**YUCCA MOUNTAIN
SITE CHARACTERIZATION
PROGRAM BASELINE
(SCPB)**

Document No. YMP/CM-0011
Revision 3
CI No. CI-11,0000/CI-13,0000
Date 2/07/92
WBS No. 1.2.3
QA Level Yes

**YUCCA MOUNTAIN SITE CHARACTERIZATION PROJECT
DOCUMENT CHANGE NOTICE (DCN) RECORD**

Figure 8.3.1.2-21a. Locations of the three proposed wells.

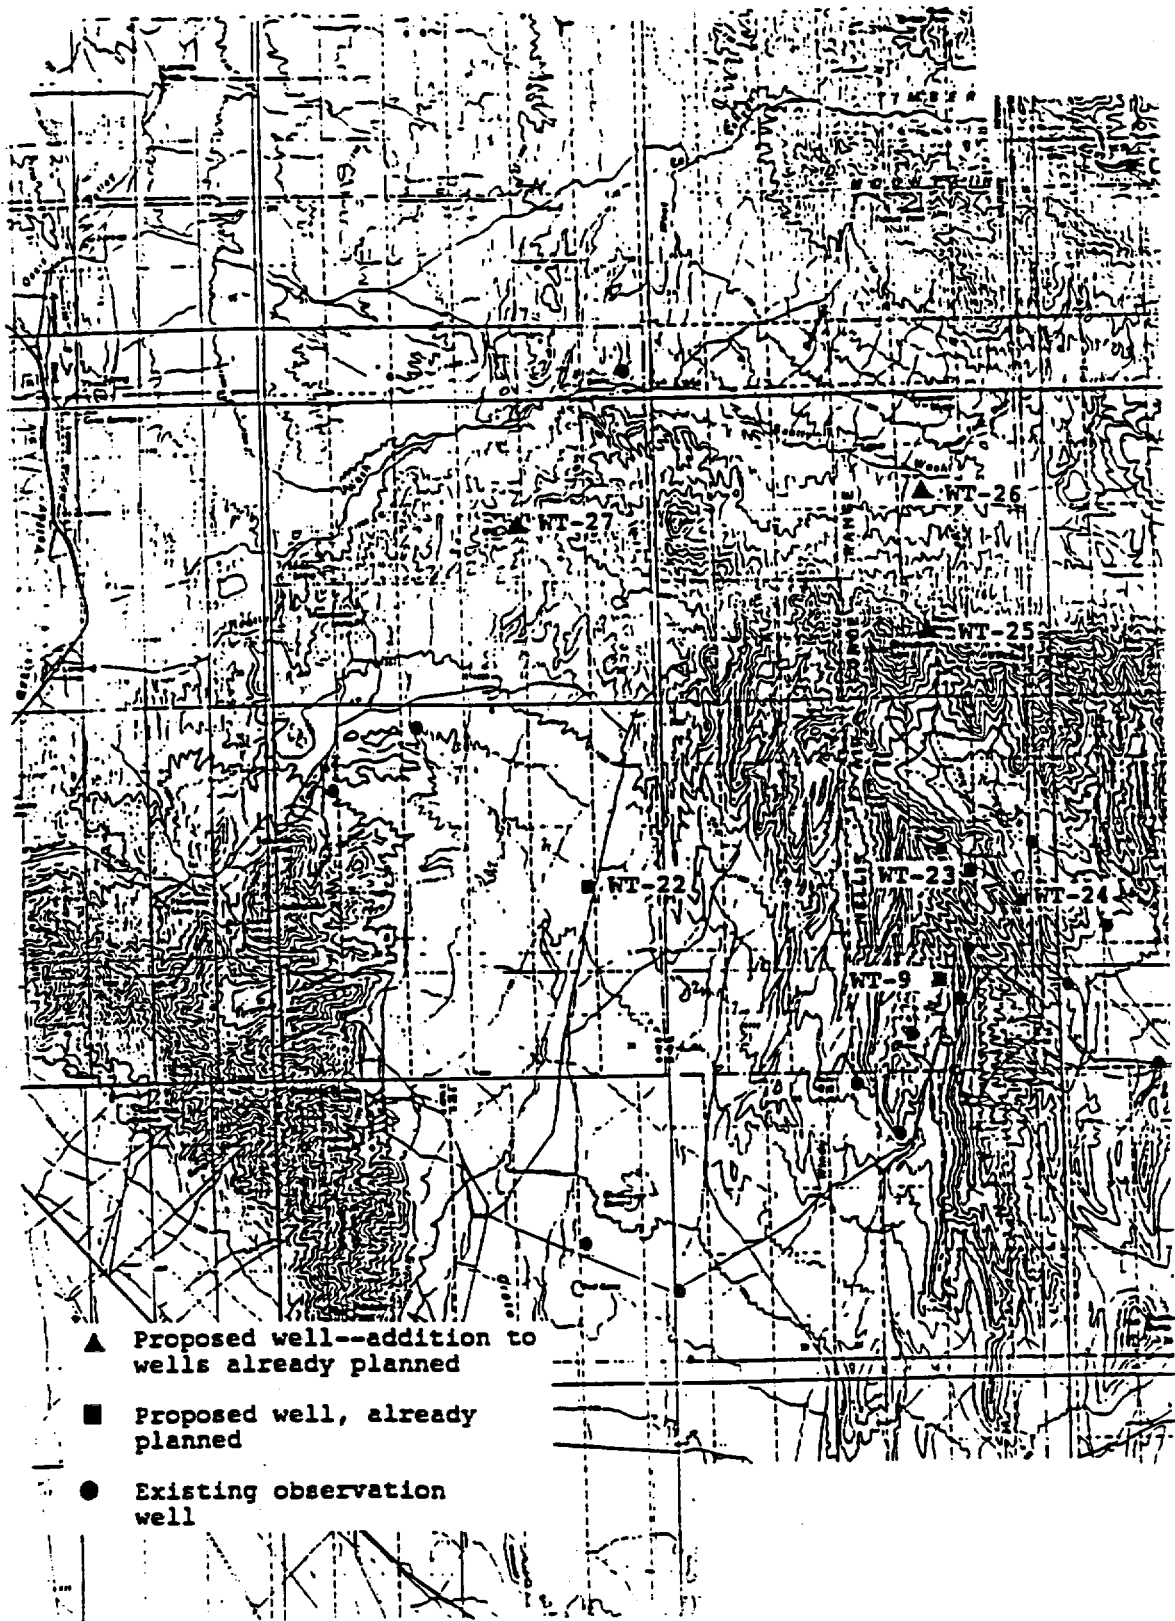
Figure 8.3.1.2-21a shows approximate locations of the three proposed wells.
